CPED STAFF REPORT

CPC Agenda Item #9
 June 23, 2014
 BZZ-6597

Property Location: 3118 Lake Street West
Project Name: 3118 West Lake Street Redevelopment
Prepared By: [Shanna Sether](#), Senior City Planner, (612) 673-2307
Applicant: ESG Architects, Inc.
Project Contact: Aaron Roseth
Request: To construct a new six-story, mixed-use building with 157 dwelling units and approximately 5,000 square feet of commercial space.

The purpose of the Preliminary Development Review (PDR) is to provide Customers with comments about their proposed development. City personnel, who specialize in various disciplines, review site plans to identify issues and provide feedback to the Customers to assist them in developing their final site plans.

C1.2

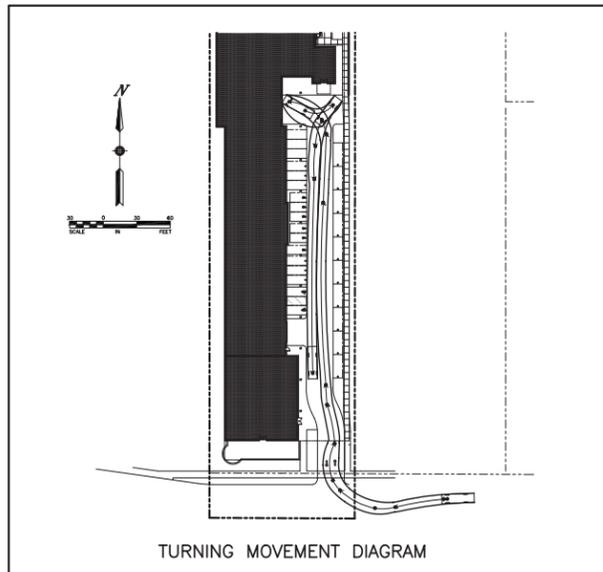
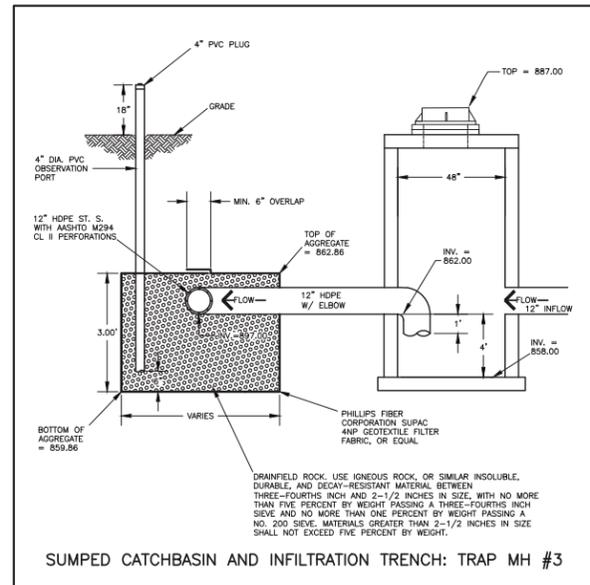
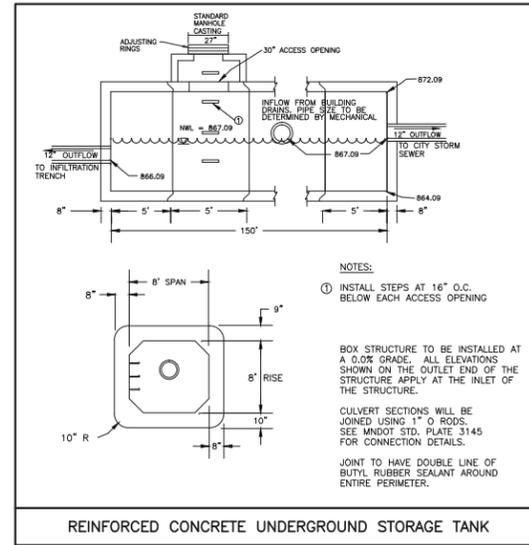
- The area drains shown on Sheet C1.2 on the east side of the site are not identified as being connected to any storm sewer pipes. Please show the pipes and connections on the plans.

- Utility: It appears that the catch basin, identified on the survey, behind the Lake Street back of curb towards the west side of the site was previously connected to slotted drains along the sidewalk in this location. It does not appear that the slotted drains are still in place. Further investigation will be completed to determine if the catch basin needs to be reconstructed, as noted on Sheet C1.2, or if it can be eliminated.
